Public Hearing Record  
County Planning Commission

Application: Genesee Properties, Inc  
Planned Unit Development /Subdivision Sketch Plan for the Society Turn Parcel;  
Mixed-Use Development Zone District Land Use Code Amendment  
Date: February 11, 2021

**TO:** San Miguel County Planning Commission  
**FROM:** Kaye Simonson, AICP, Planning Director  
**RE:** A. Society Turn PUD and Subdivision Sketch Plan  
B. Land Use Code Amendment to create MXD Mixed Use Zone District  
**DATE:** February 11, 2021  
Z:\Applications\2020\_Genesee Properties, Inc.\_LUCA\_Rezone\_PUD\_Society Turn Parcel\1 Staff Memo(s) and Resolution(s)]

Site Plan  
(Exhibit B1)

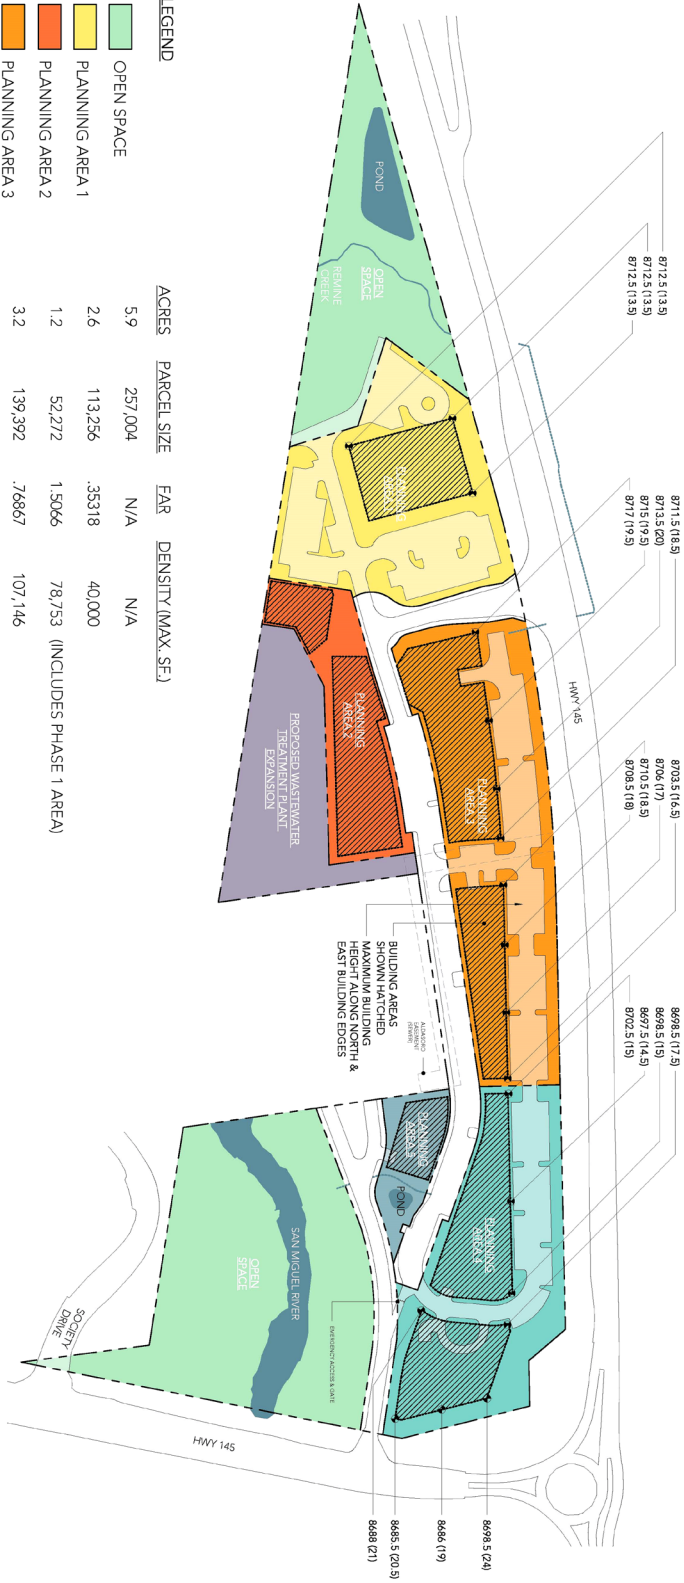
- The Site Plan, Exhibit B1, shows the re-alignment of the Remine Creek Trail as going around the perimeter of the Society Turn Parcel and connecting directly with the bike path at the pedestrian underpass. The proposed trail connection to the bike path near the pedestrian underpass would require engineered concrete work and an engineered railing. This connection would also be unsafe for bikes and pedestrians at the "T" connection to bike path near the underpass. It also shows the trail going up and over the small hill / glacial moraine on the northeastern corner of the parcel near the roundabout. **Could the applicant please describe in detail their plans for the re-alignment of the Remine Creek Trail and if the proposed re-alignment will exist on the CDOT Highway 145 ROW?**
